Errata Sheet

Rel. 1.4, 2021-01

Device	**XMC4100/XMC4200**
Marking/Step	**ES-BA, BA**
Package	**PG-VQFN-48, PG-(LT)QFP-64**

Document ID is **121/17**.

Figure 1 Influence of concurrent conversions on reference voltage

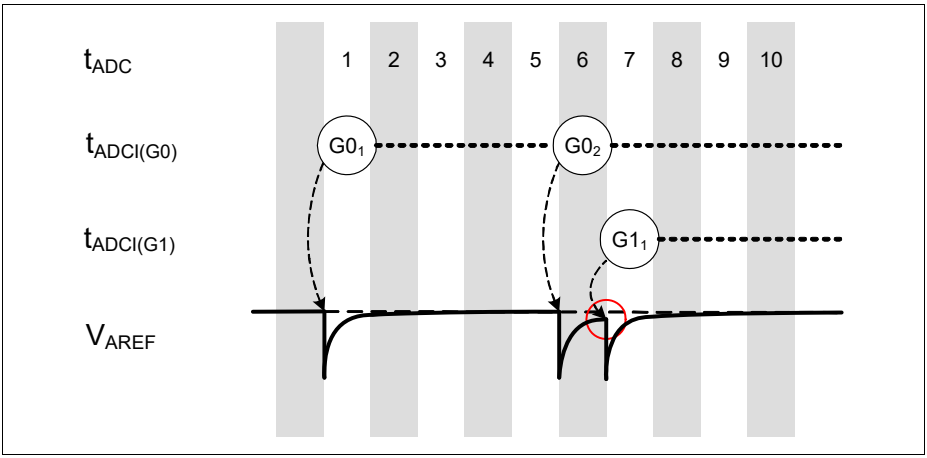
In cycle 1 only the G0 conversion step is started. At start time the reference voltage is strobed and a certain amount of electric charge (see data sheet parameter Q_{CONV}) is consumed. This causes a drop of the reference voltage level V_{AREF}. Quantity of voltage drop depends on analog voltage level to convert.

In cycle 6 another G0 conversion step is starting and in cycle 7 a G1 conversion step. In this case the reference voltage may not yet be fully recovered when the G1 conversion step strobes V_{REF}. Consequently, the G1 conversion step yields an incorrect value.

In repeated mesurements using the example setup errors up to 25 LSB have been observed in 10-16 of 4096 conversions. Magnitude of the error however depends on the system configuration and load. The workaround therefore should be applied for all applications.

If two or more converter groups (G0-G3) are started (initialized) asynchronously and multiple conversion steps or sample phases occur in the same time frame then the reference voltage settling time can be violated, which leads to incorrect conversion results.

The workaround makes sure that all ADC group clocks $f_{ADCI(Gx)}$ are started concurrently. Even if your application does not require a master/slave configuration this sequence ensures a synchronized start behaviour.

1. Disable all ADC groups (x=0-3) by clearing ASENy (y=0-2) bits:`GxARBPR.ASENy = 0`
2. Configure the queue, scan and background sources as required.
3. Configure one group as master, others as slaves and set EVALRy (y=1-3):
```
GxSYNCTR.EVALRy = 1 G0SYNCTR.STSEL = 00 -- G0 is master
0 G1SYNCTR.STSEL = 01 -- G1 is slave of master 0
G2SYNCTR.STSEL = 01 -- G2 is slave of master 0
G3SYNCTR.STSEL = 01 -- G3 is slave of master 0
```
4. Configure the slave groups G1, G2, G3
```
GxARBCFG.ANONC = 00 -- Converter off
-- Remaining GxARBCFG bits are set as required
```
5. Configure the master G0
```
G0ARBCFG.ANONC = 11 -- Converter on
-- Remaining GxARBCFG bits are set as required
```

Figure 2 Parity Checker diagram

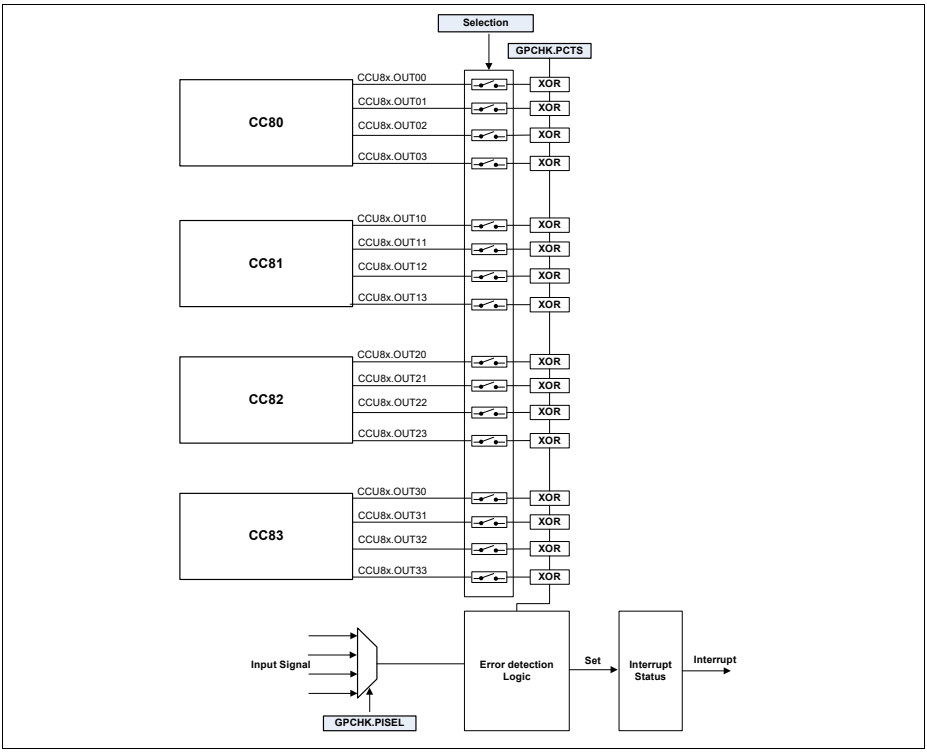
Each CCU8 module also contains a function called Parity Checker. This Parity Checker function, crosschecks the output of a XOR structure versus an input signal, as seen in Figure 1.

When using the parity checker function, the associated status bitfield, is cleared automatically by hardware in the next PWM cycle whenever an error is not present.

This means that if in the previous PWM cycle an error was detected and one interrupt was triggered, the software needs to read back the status register before the end of the immediately next PWM cycle.

Not ORing the Parity Checker error interrupt with any other interrupt source. With this approach, the software does not need to read back the status information to understand what was the origin of the interrupt - because there is only one source.

Figure 5 PWM output glitch

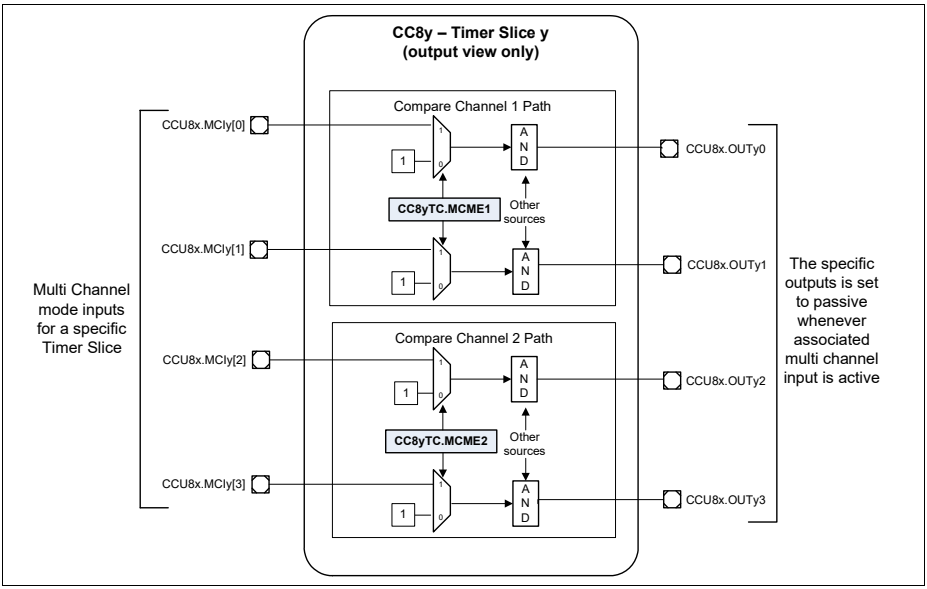
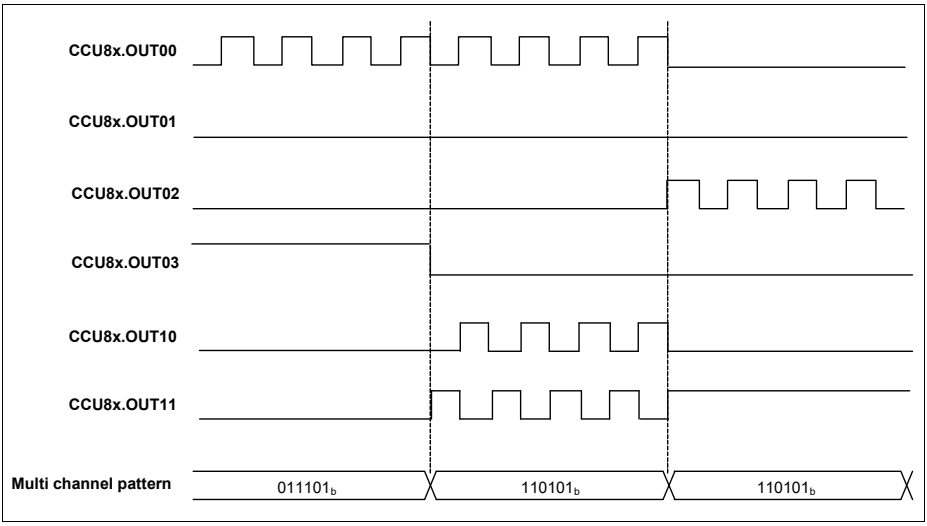
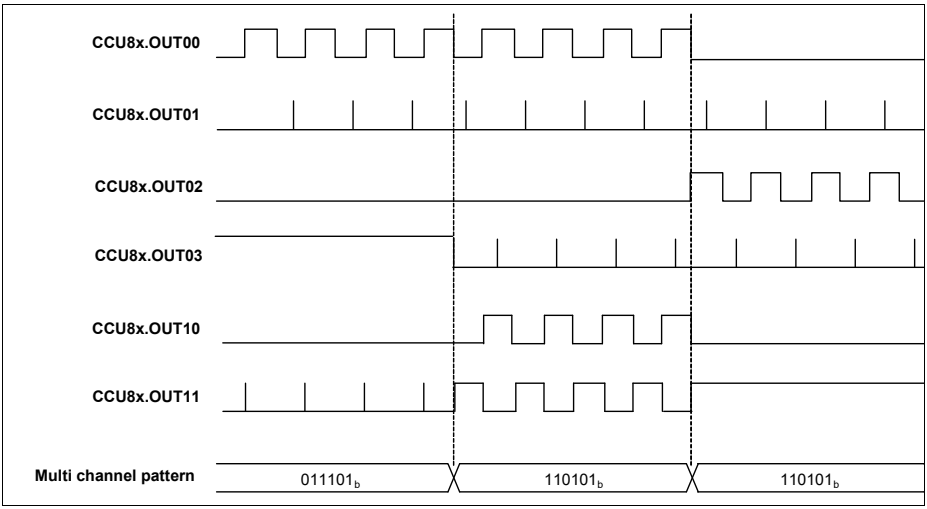
A glitch is present at the PWM outputs whenever the dead time of the specific compare channel is enabled - CC8yDTC.DTE1 and/or CC8yDTC.DTE2 set to 1_B (each compare channel has a separate dead time function) - and the specific multi channel pattern for the channel is 01_B or 10_B.

This glitch is not present if the specific timer slice is configure in symmetric edge aligned mode - CC8yTC.TCM = 0_B and CC8yCHC.ASE = 0_B.

This glitch only affects the PWM output that is linked to the inverting ST path of each compare channel (non inverting outputs are not affected).

The effect of this glitch can be seen in Figure 3. The duration of the PWM glitch has the same length has the dead time value programmed into the CC8yDC1R.DT1F field (for compare channel 1) or into the CC8yDC1R.DT2F.

To avoid the glitch on the inverting path of the PWM output, one can disable the dead time function before the Multi Channel Pattern is set to 01_B or 10_B. Disabling the dead time of the inverting PWM output can be done by setting:

```
CC8yDTC.DCEN2 = 0 //if compare channel 1 is being used
```

```
CC8yDTC.DCEN4 = 0 //if compare channel 2 is being used
```

The dead time needs to be re enabled, before the complementary outputs become modulated at the same time:

```
CC8yDTC.DCEN2 = 1 //if compare channel 1 is being used
CC8yDTC.DCEN4 = 1 //if compare channel 2 is being used
```

Figure 6 CCU8x concatenation feature resource configuration - a) without external count function; b) with external count function

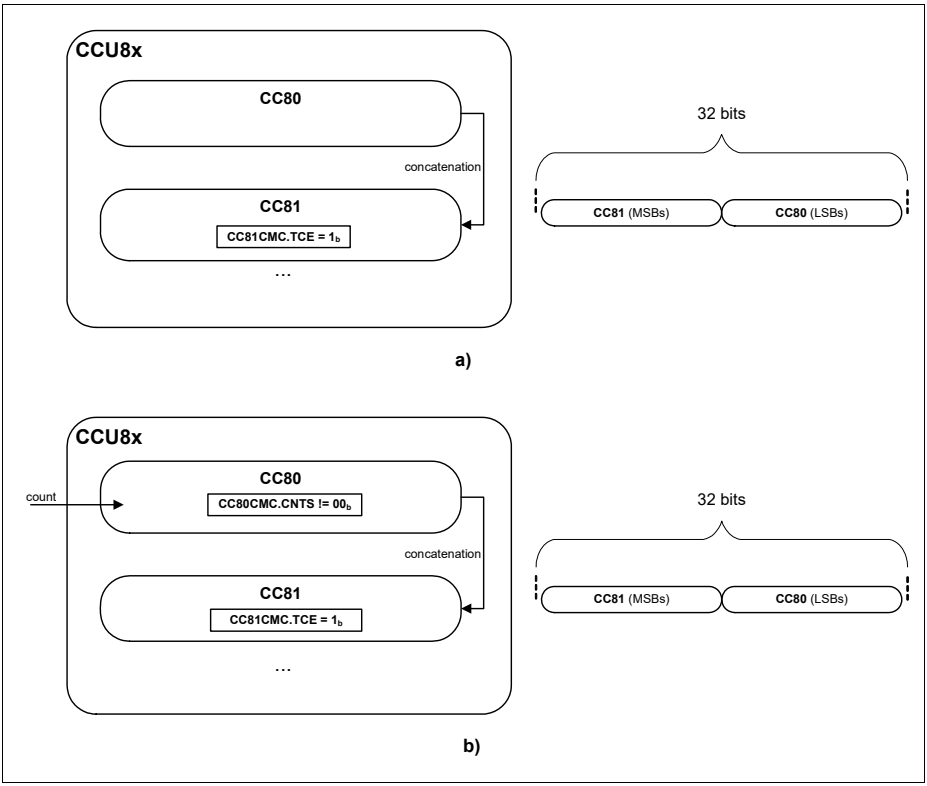
When an external count signal is enabled - by programming the CC8yCMC.CNTS with 01_B, 10_B or 11_B - the concatenation function does not work. One cannot use in parallel the timer concatenation and external count signal features.

Note: On Figure 1, the count signal is used in CCU80 because this timer represents the LSBs. While the count signal could be enabled in the MSB timer (CC81), this does not make sense when the timers are concatenate - because the count should be used to increment the LSB timer. The LSB timer will then in each wrap around, increment the MSB timer.

Figure 7 Extended Read Back access - example for CCU4 (CCU8 structure is the same)

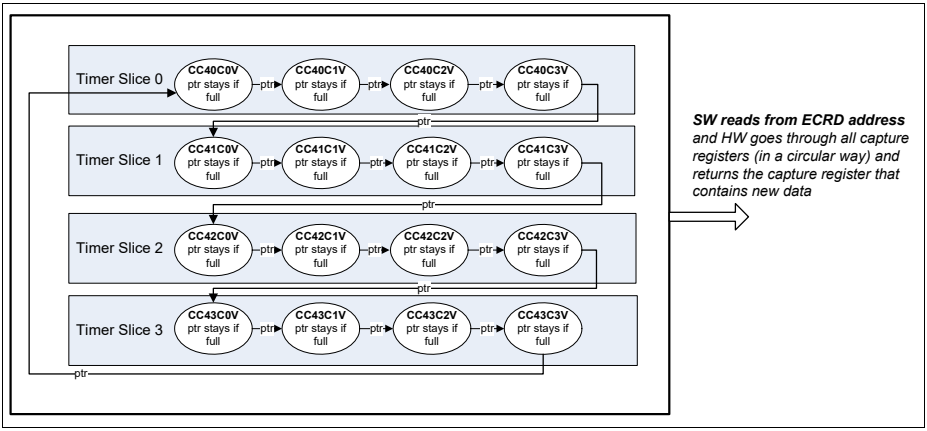
Referring to **Figure 7**, the hardware every time that the software reads back from the ECRD address, will return the immediately next capture register that contains new data. This is done in a circular access, that contains all the capture registers from the Timer Slices that are working in capture mode.

When using this feature, there is the possibility of losing captured data within a Timer Slice. The data that is lost is always the last captured data within a timer slice, e.g (with CCU4 nomenclature - same applies to CCU8):

Figure 8 Clock Selection Diagram for CCU4/CCU8

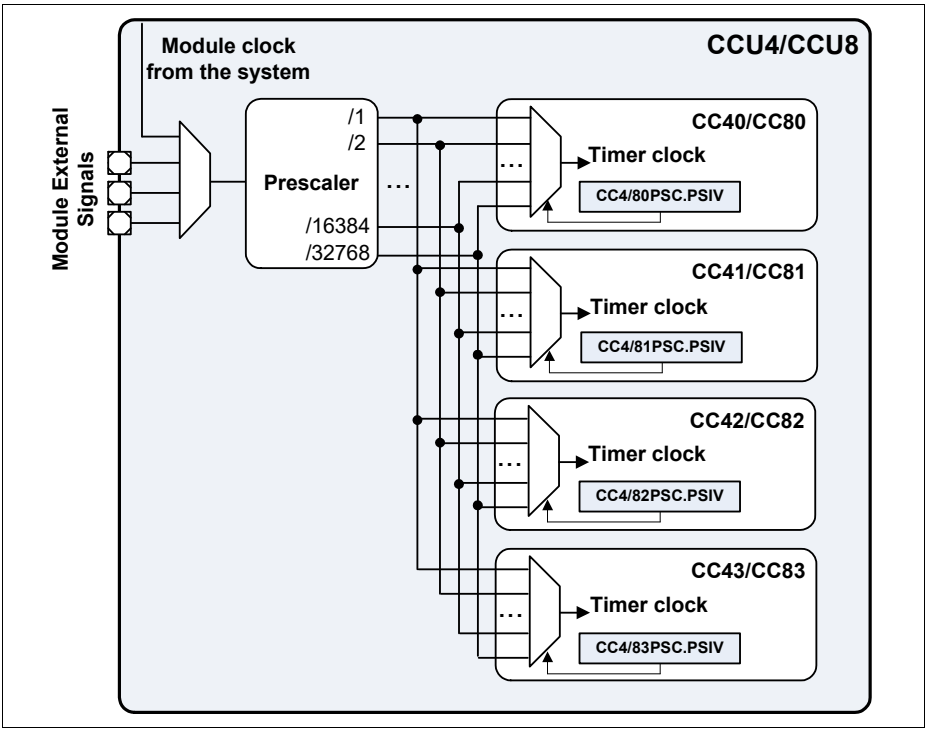
Currently is only possible to use an external signal as Timer Clock when a division ratio of 2 or higher is selected. When no division is selected (divided by 1), the external signal cannot be used.

The user must program the PSIV field of each Timer Slice with a value different from 0000_B - minimum division value is /2.

Figure 9 PADT update behavior

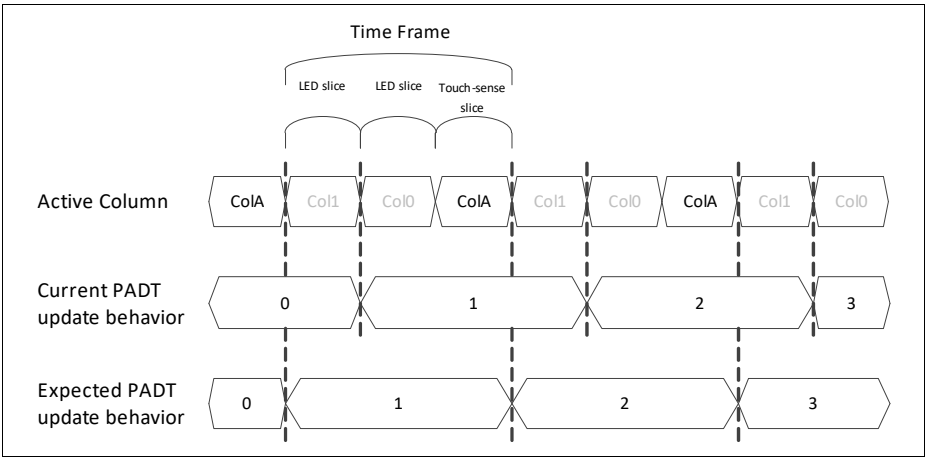
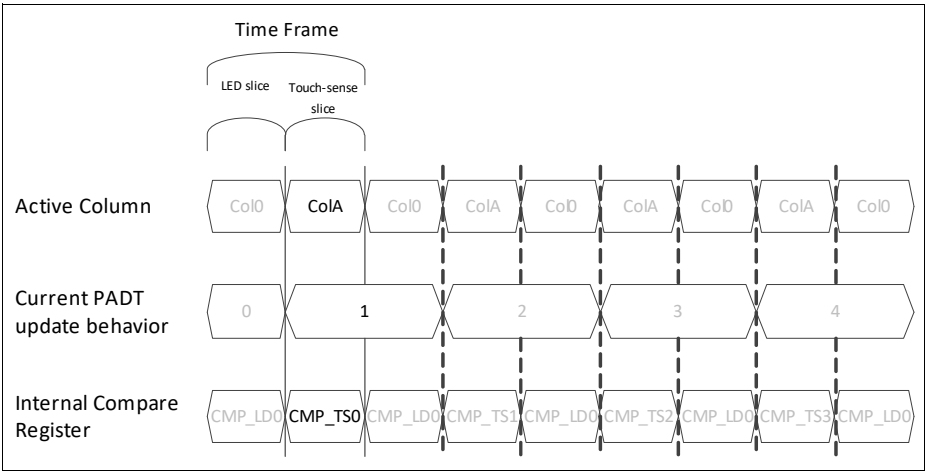
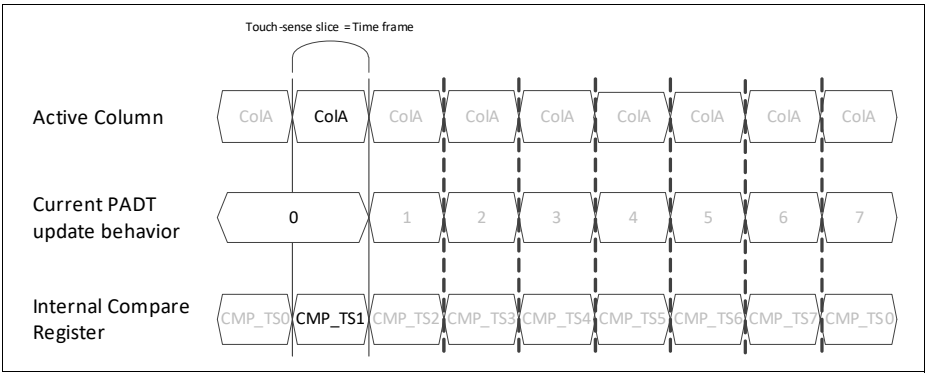
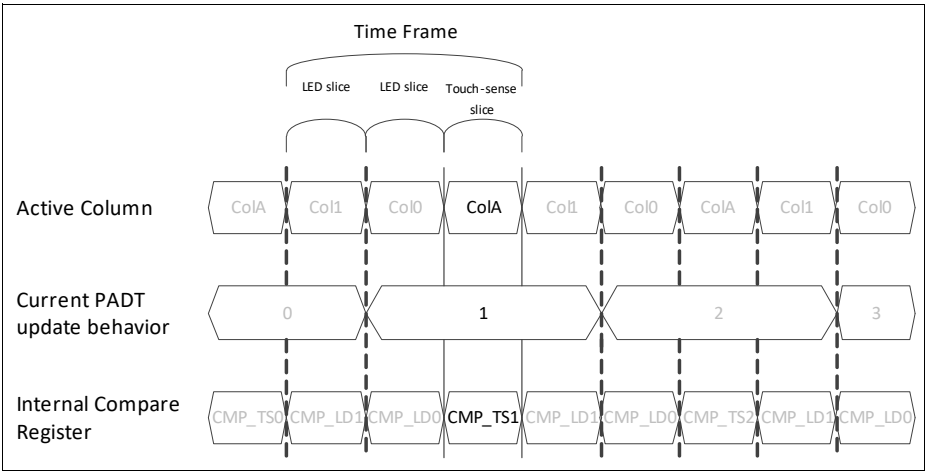
The touch-sense pad turn (PADT) value is updated, not at the end of the touch-sense time slice (ColA), but one time slice later (**Figure 9**).

If the number of LED columns enabled is smaller than 2, the delay will affect the activation period of the current active pad. At the beginning of every new Col A, the value of the current PADT's compare register is updated to the internal compare register. However, the delay causes the value of the previous PADT's compare register is updated to the internal compare register instead. This means that the current active pad would be activated with the duration of the previous pad's oscillation window (**Figure 10**). In addition to this, when no LEDs are enabled, pad turn 0 will prevail for one time slice longer before it gets updated (**Figure 11**).

If the number of LED columns enabled is 2 or more, the additional LED columns would provide some buffer time for the delay. So, at the start of a new touch-sense time slice, the update of PADT value would have taken place. Hence, the current active PADT compare register value is updated to the internal compare register (**Figure 12**).

Figure 16 Index usage workaround - a) Non working solution; b) Working solution

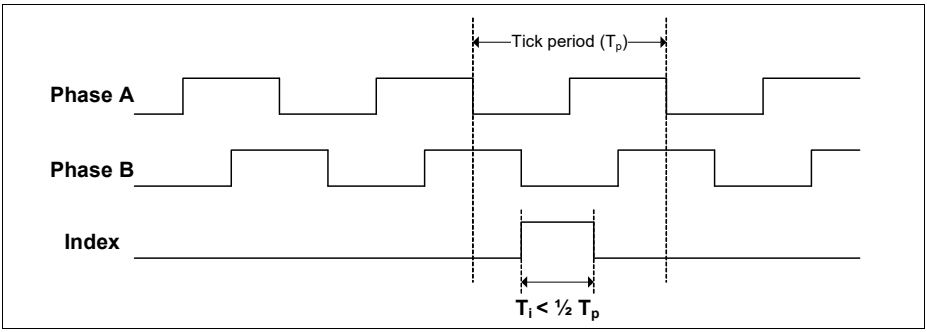
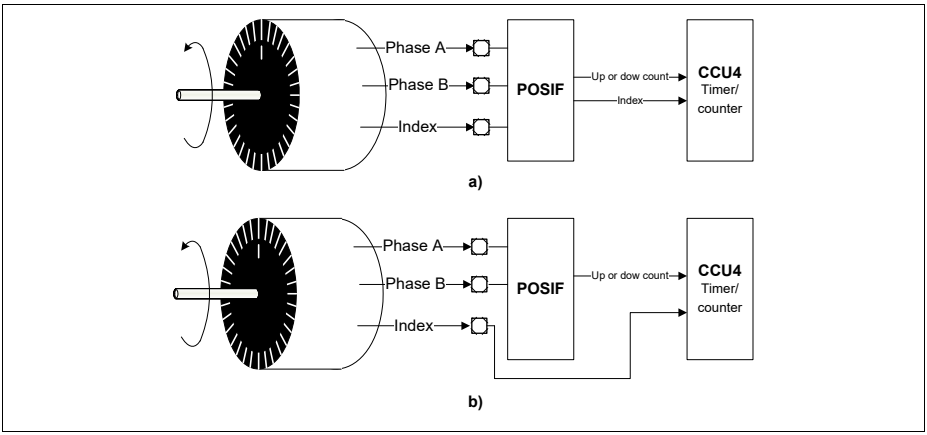
When the index signal is smaller than 1/2 of the tick period, the POSIF module is not able to decode this signal properly, Figure 2 - notice that the reference edge of the index generation in this figure is the falling of Phase B, nevertheless this is an example and depending on the encoder type, this edge may be one of the other three.

Due to this fact it is not possible to use the POSIF to decode these type of signals (index with duration below 1/2 of the tick period).

To make usage of the Index signal, when the length of this signal is less than 1/2 of the tick period, one should connect it directly to the specific counter/timer. This connection should be done at port level of the device (e.g. connecting the device port to the specific Timer/Counter(s)), Figure 3.

Figure 19 ABM/PSRAM Header - Location of reserved bytes

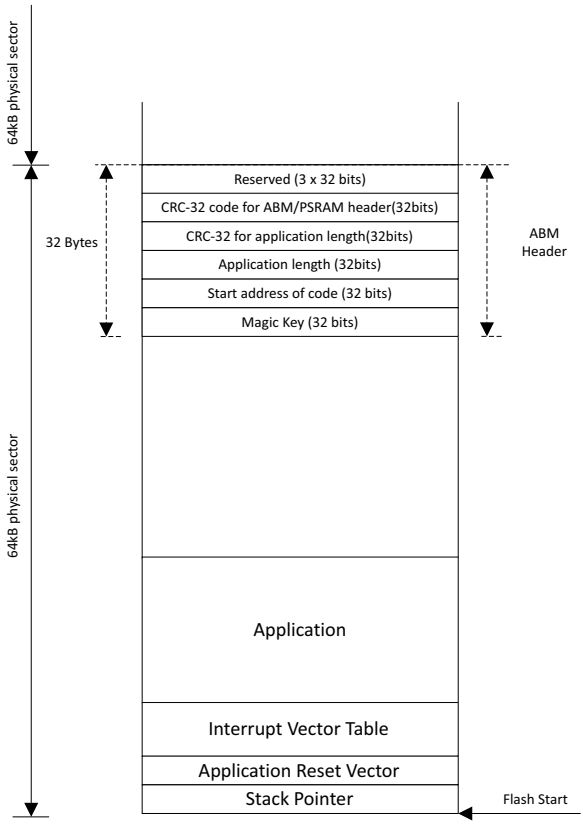
The following figure provides a detailed view on the location of the reserved bytes:
